SUBJECT: DF61 Dirty Mark on Back-side of Original

Phoenix-series
(DF61)

Model: DF61 (Phoenix series)		Date: 15-Aug-97	No: 20
Subject: Bent Original		Prepared by: S.Hizen	
From: QAC 1st Field Information Dept.			
Classification:	<input checked="" type="checkbox"/> Troubleshooting	<input type="checkbox"/> Part information	<input type="checkbox"/> Action required
	<input type="checkbox"/> Mechanical	<input type="checkbox"/> Electrical	<input type="checkbox"/> Service manual revision
	<input type="checkbox"/> Paper path	<input type="checkbox"/> Transmit/receive	<input type="checkbox"/> Retrofit information
	<input type="checkbox"/> Other ()

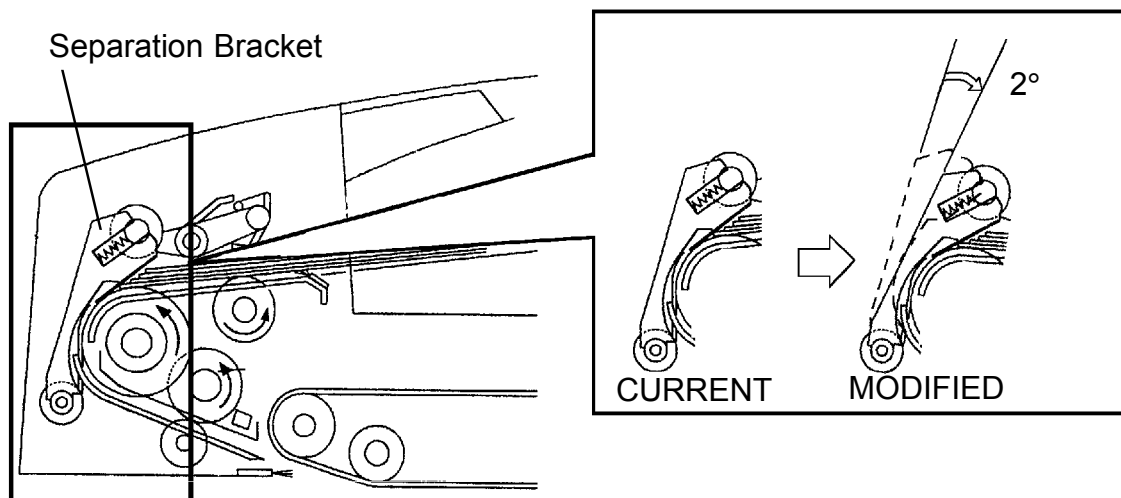
Problem: Three dirty marks on the back side of the original.

Cause: The toner on the first original is transferred to the back of the second original due to the pressure applied by the pressure lever and the pick-up roller.
(See the illustration)

The dirty marks created are one of the limitations of the DF61. The degree to which the marks appear varies depending on how completely the image on the first original is fused, the type of image, and the type of paper used.

Due to this countermeasure for the DF61, the specifications listed in the service manual have been changed as follows:

Specification Item	Current DF	Modified DF
Original Weight	52 to 128 g/m ²	52 to 104 g/m ²
Original Table Capacity	50 sheets at 80 g/m ²	35 sheets at 80 g/m ²

Separation Bracket

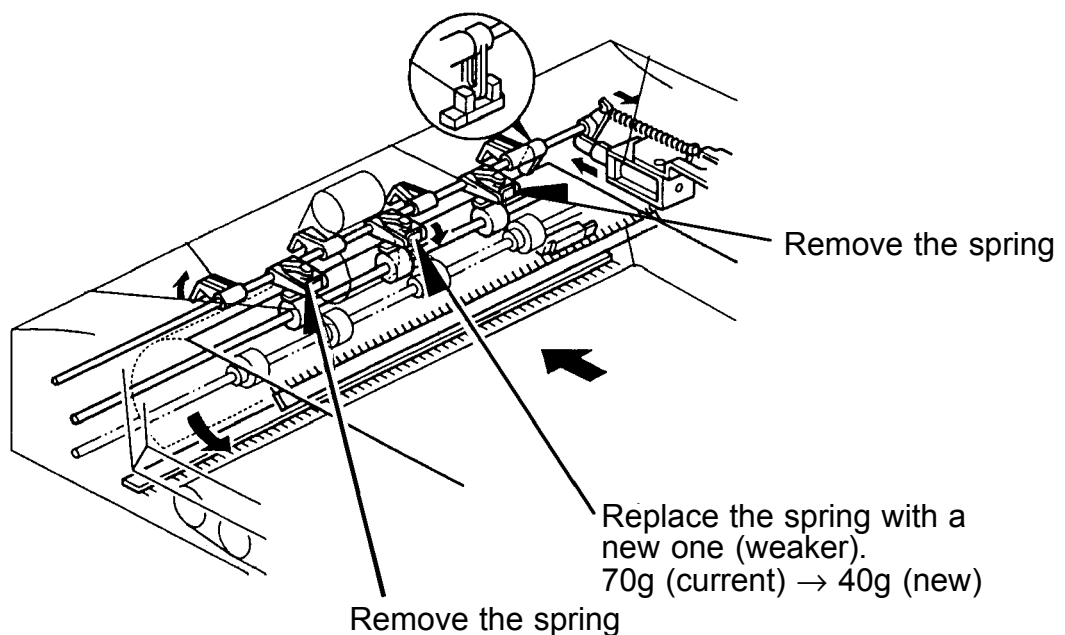
The countermeasure for the dirty marks is designed to reduce the pressure applied to the originals by replacing the entrance guide stopper spring with a new one. This change also results in a decrease in the amount of force used to feed the original and may create an original non-feed problem. Therefore, the separation bracket has been modified to reduce the angle by 2 degrees.

1. Remove the three springs from the entrance guide stopper and install the new spring (P/N:A548 9500) in the middle. If an original non-feed occurs, add the outside springs (P/N:A548 9500) on both sides.

The angle between the separation belt and the originals, and the symptoms caused by the angle.

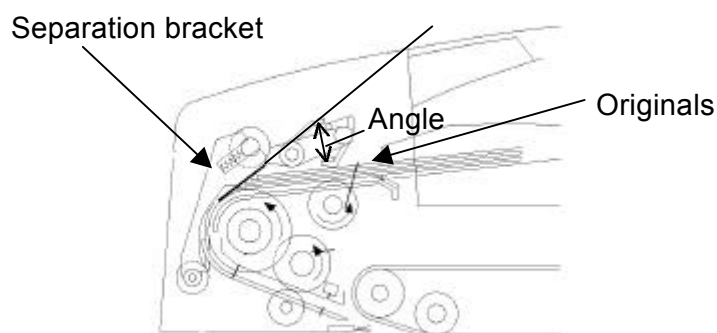
There is a bend (wrapping) on the leading edge of the original the same size as the width of the separation belt. If the bend in the original is large, dirty background may appear on the copy in the area that corresponds with that bend.

The problem occurs as a result of the contact between the edge of the original and the separation belt when the original is fed to the exposure glass. If the upward curl of the original is large or the cut in the leading edge of the paper is not smooth, this problem is more likely to occur.

Large: Good for separation, marginal for original leading edge bending

Small: Good for original leading edge bending, marginal for double-sheet feeds.

The Separation Belt Tension also affects the angle

Strong: If the tension is strong, the angle is relatively large.

Weak: If the tension is weak, the angle is relatively small

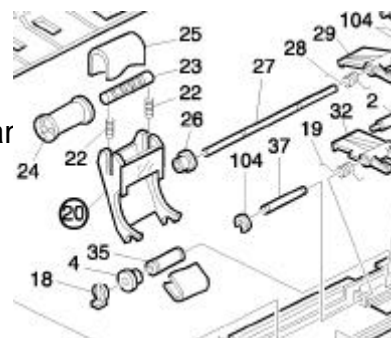
This problem can be resolved by reducing the angle of the belt, which will help original entrance, or by lowering the guide mylar by 1 mm to reduce the resistance of the original.

Change the separation belt bracket (A5481291: #20 in the diagram on the right) and the spring to reduce the angle between the original and the belt and also decrease the force from the belt on the edge of the original.

Replacement Part Number: A5489504

Separation bracket

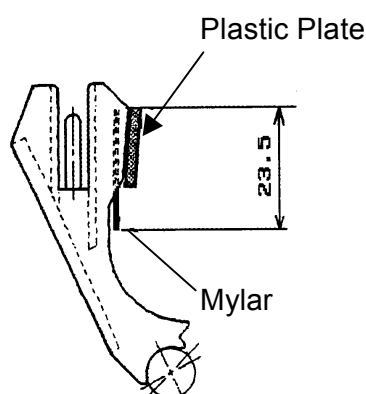
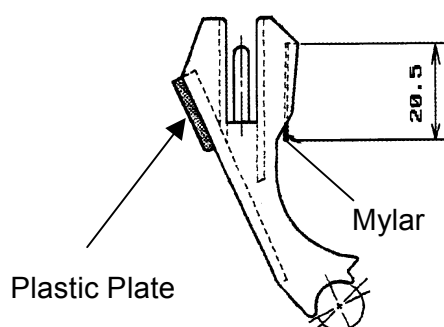
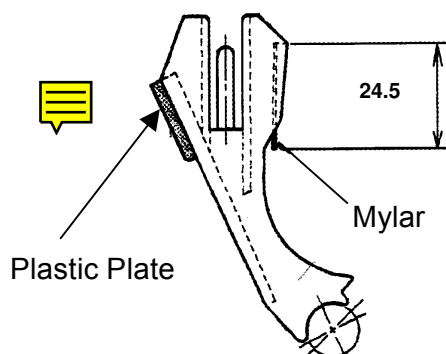
The chart below clarifies the modifications made to the separation bracket.

Mass-production.

A548-1291

Bracket Spring: AA06-3503

Bracket for the dirty mark
on the back side of original.

A548-9502

Bracket for the leading edge
bend.

A548-9504

(This number is for the Bracket and the Spring)
